New School Openings St. Patrick Catholic Elementary School

Version: 1.0
Revision Date: May 28, 2025

School Profile

A1.1

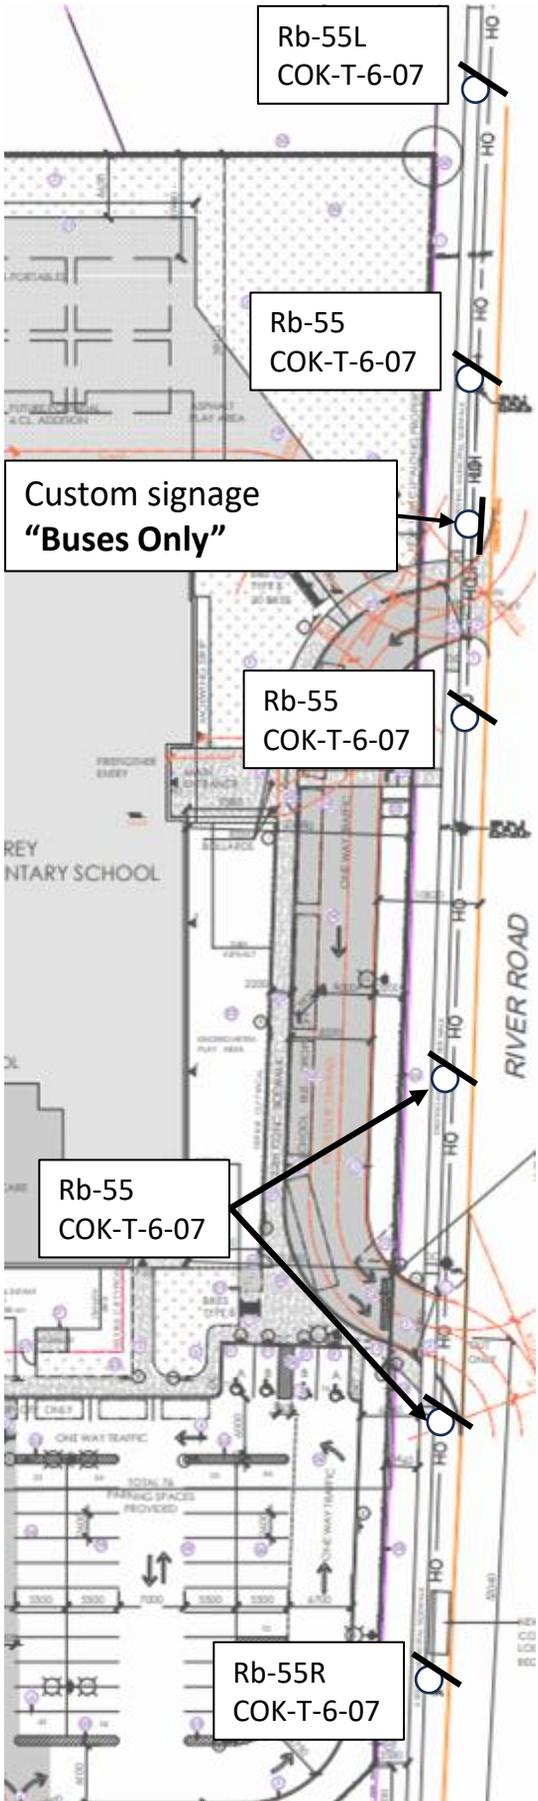
No signage was proposed on the Site Plan at the entrance from River Road that identifies the area is to be used exclusively as a School Bus Loading Area and/or Fire Route. "Do Not Enter" signs will face easterly at the outbound only access to River Road.

The Site Plan does not identify signage to restrict vehicle stopping or parking along the site's frontage to adjacent roadways.

It is recommended to install signage at the inbound entrance identifying that only school buses are permitted to use the access. The WCDSB has confirmed that signage will be updated based on this recommendation.

The WCDSB has noted that the on-site signage will be updated based on this recommendation.

Appendix B: Recommended Signs and Approximate Locations

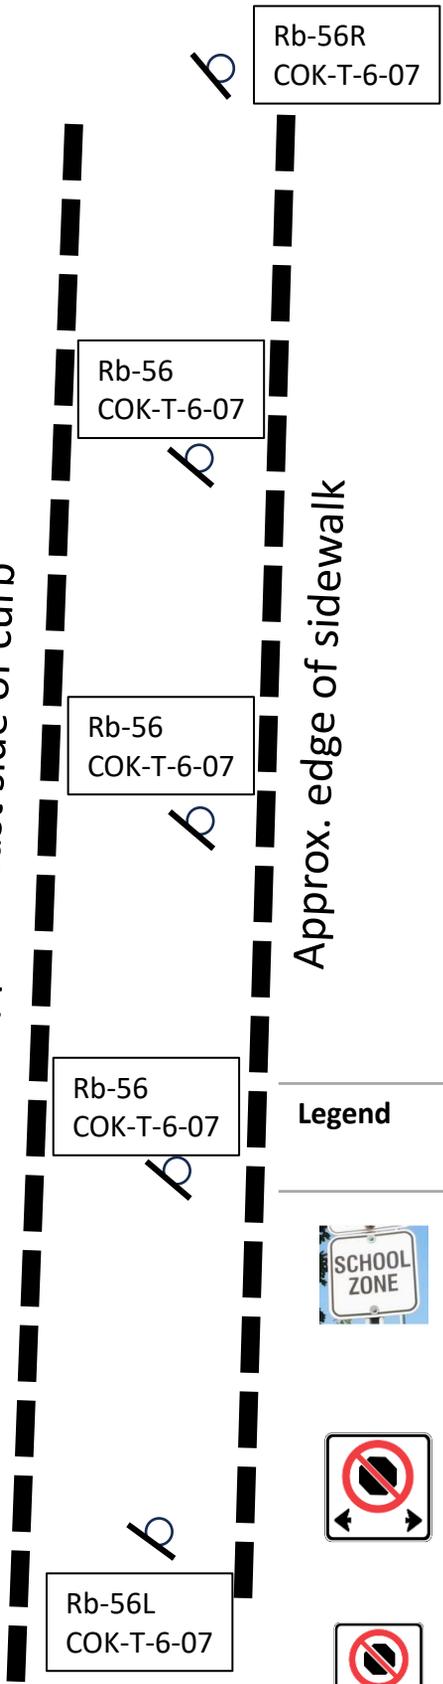
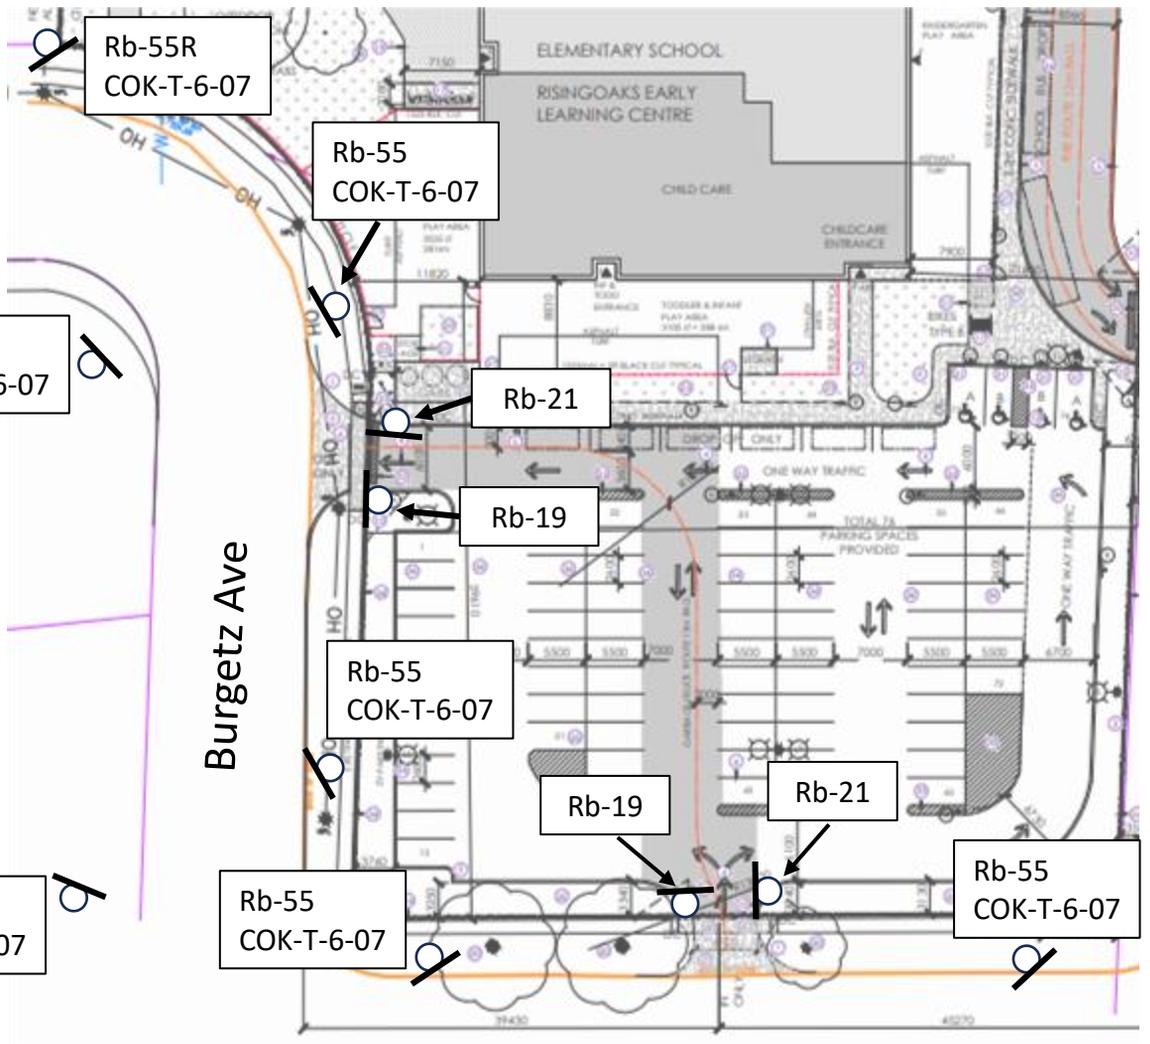
It is recommended that Rb-55 (No Stopping) signs are installed along all roads abutting the school's frontage and Rb-56 (No Stopping with Time Restrictions) signs are installed on the opposite side of abutting roads. On River Road, the No Stopping southern limits should be the north side of the existing Grand River Transit (GRT) bus stop.

All Rb-55 and Rb-56 signs should be installed in accordance with Ontario Traffic Manual (OTM) Book 5, which identifies a maximum spacing of 50 metres. All Rb-56 signs should note the time restriction as 8:00 AM to 4:30 PM, as noted in Section V.8.b.iii of Traffic By-law 2019-113.

1. Entrance to Kinzie Avenue
 - a. Rb-19 (Do Not Enter) sign facing northwards.
 - b. Rb-21 (One-Way) sign parallel to the flow of traffic.
2. Exit to Burgetz Avenue
 - a. An additional Rb-19 (Do Not Enter) sign facing westerly, so there is an Rb-19 on both sides of the exit.
 - b. Rb-21 (One-Way) sign parallel to the flow of traffic.
